LAKE TAHOE COMMUNITY COLLEGE
Student Housing Building Project
RFP #22-23-002
Addendum #1

PROJECT: RFP #22-23-002 – Student Housing Building Project

DATE: June 22, 2023

Description(s): Revised Increment 1 Drawings to show:

5 EAST ELEVATION
1/4" = 1'-0"

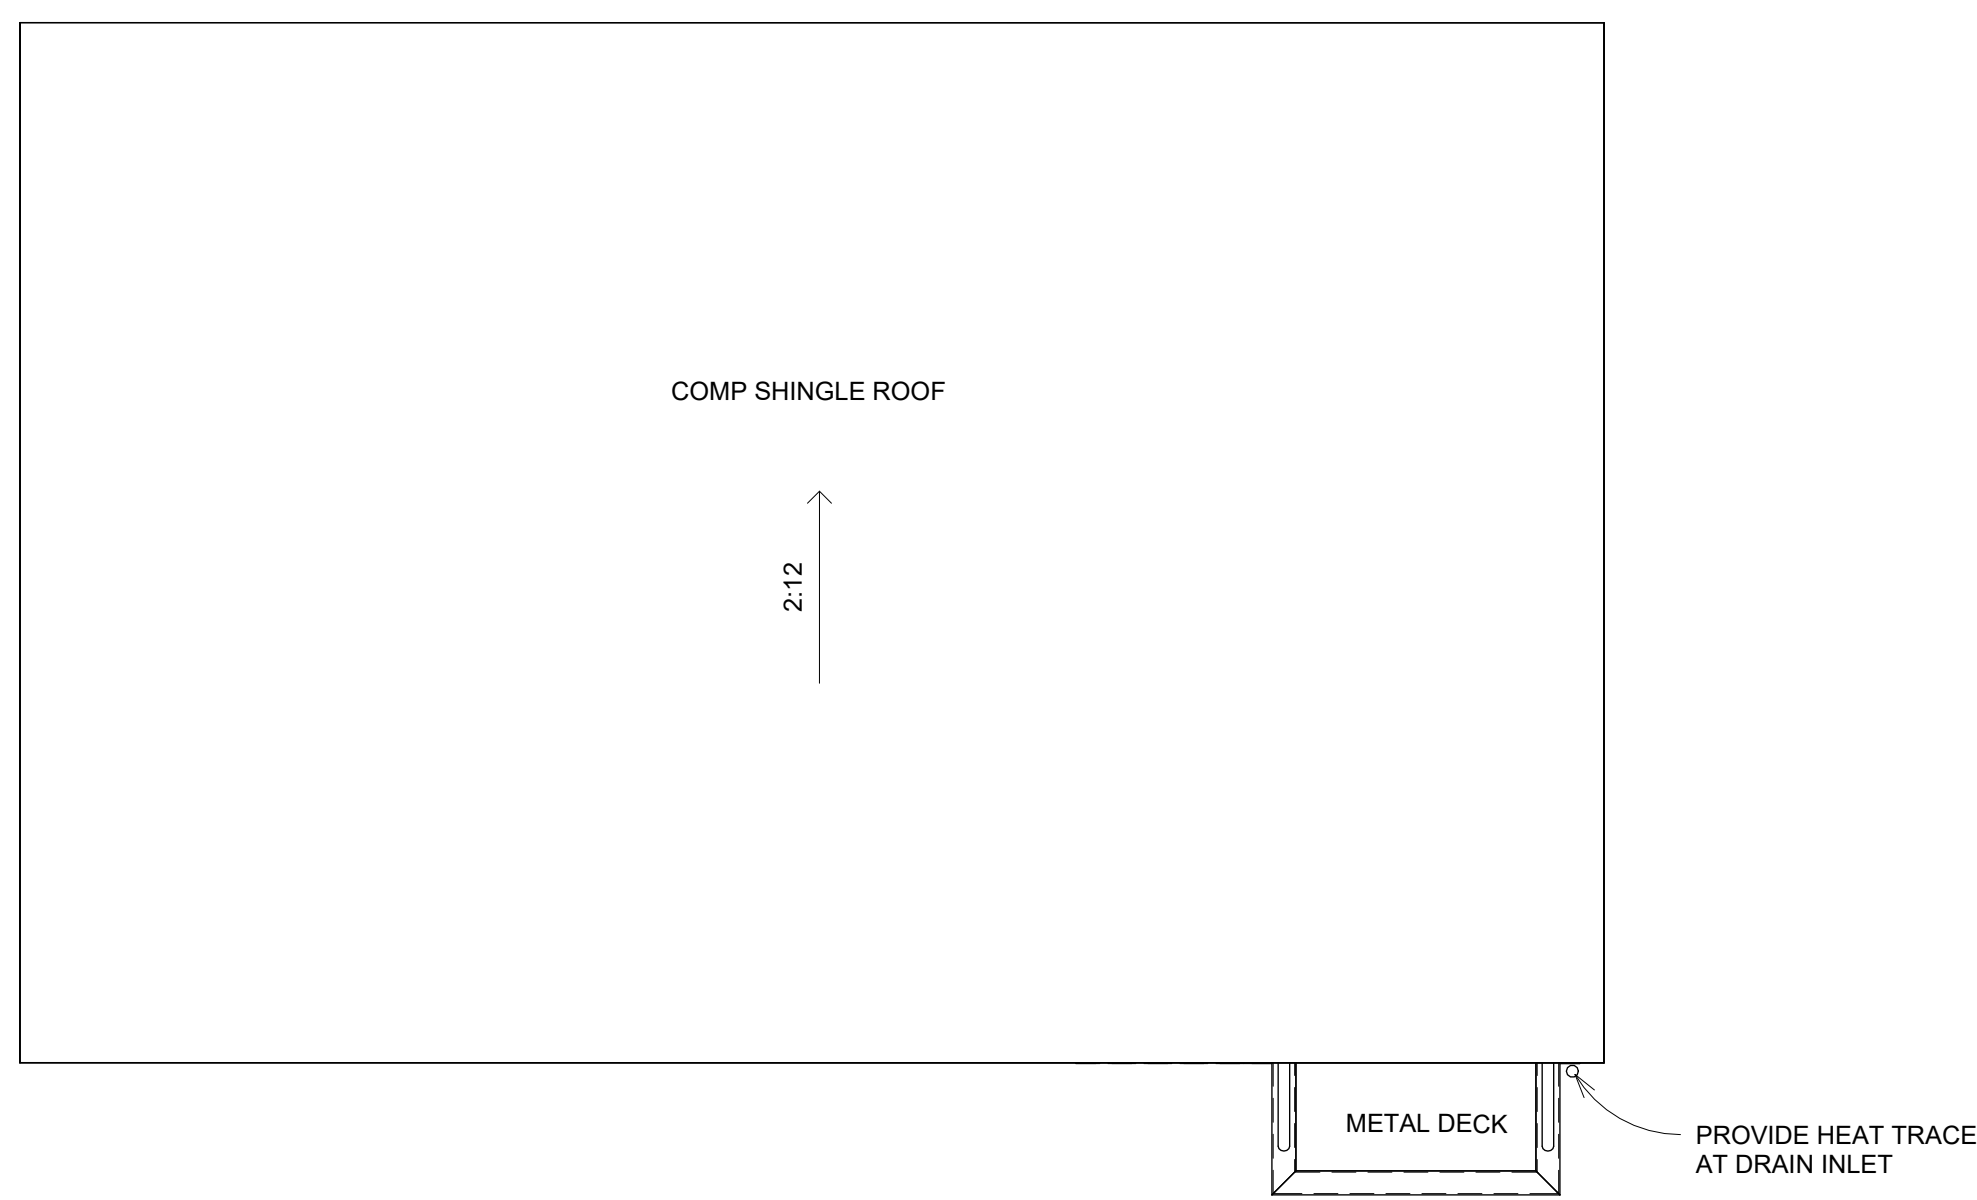
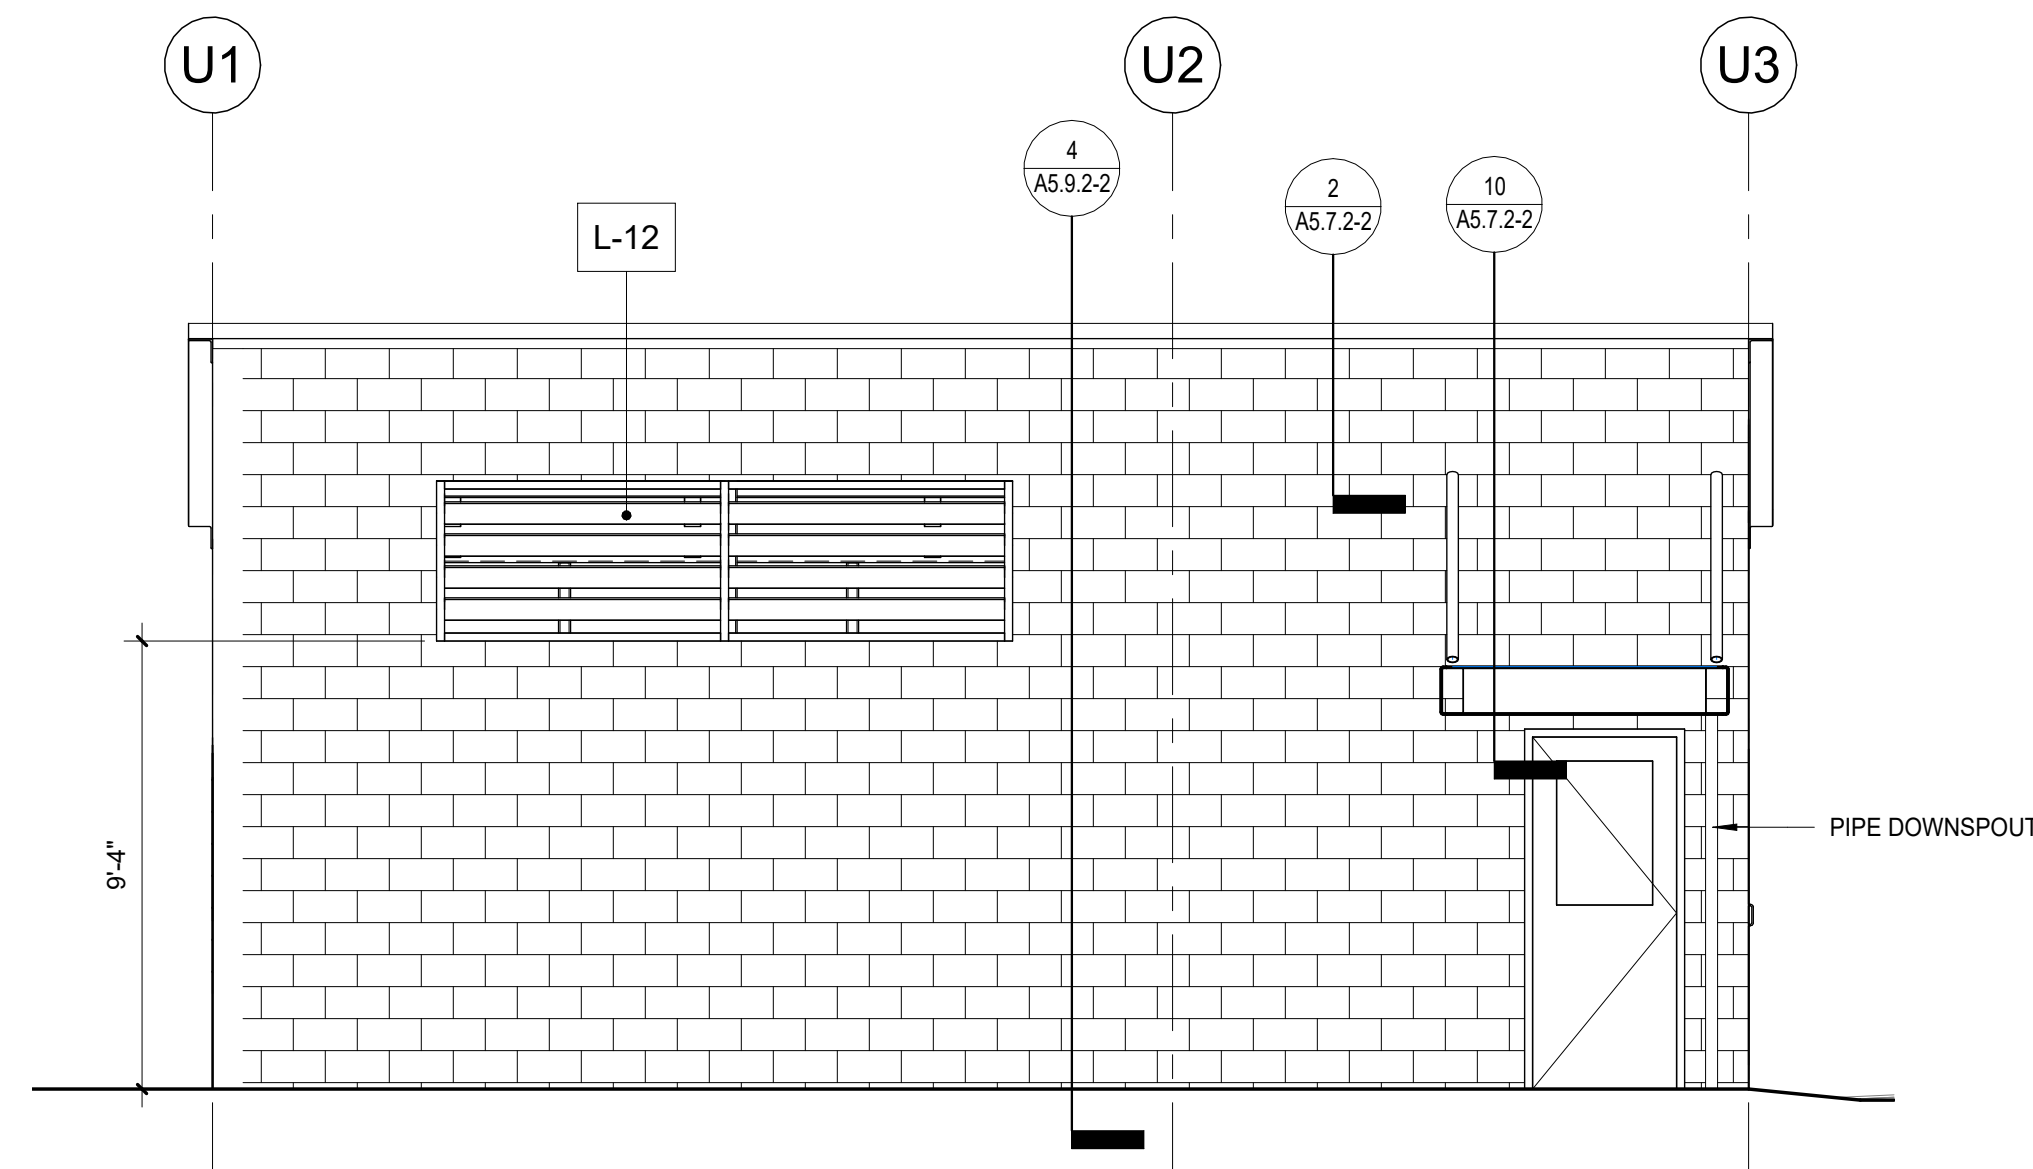
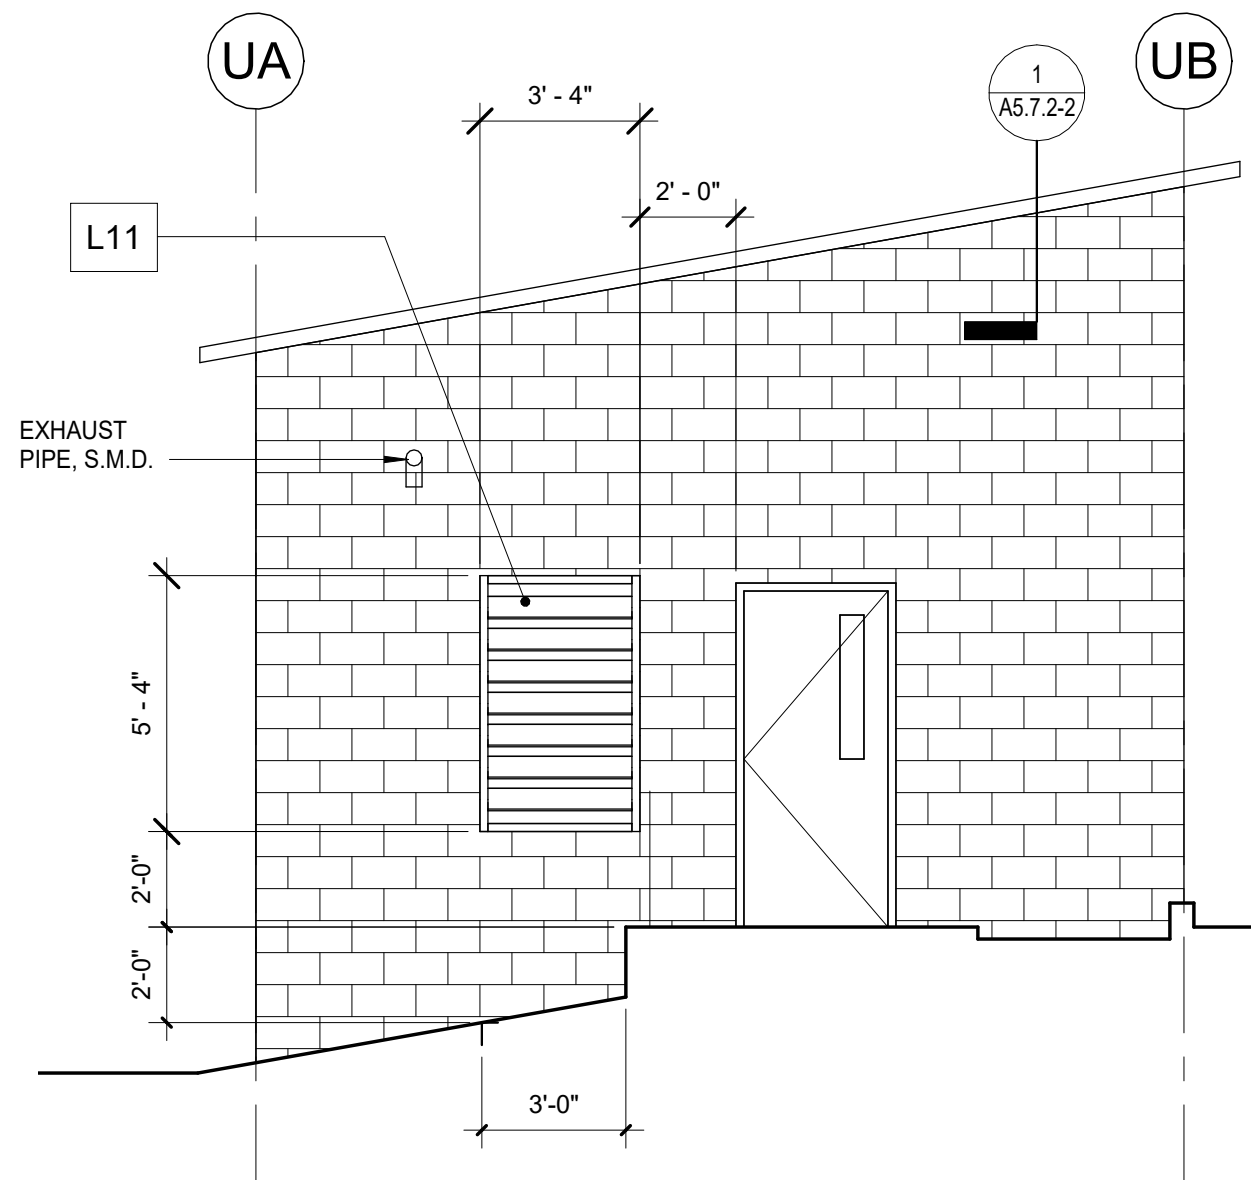
- Removed footing step on Gridline U2.
- Added Electrical Conduit Penetration notes.
- Clarified CMU wall below the gates.
- Adjusted lean mix shown in Elevation 2/S2.06-2.
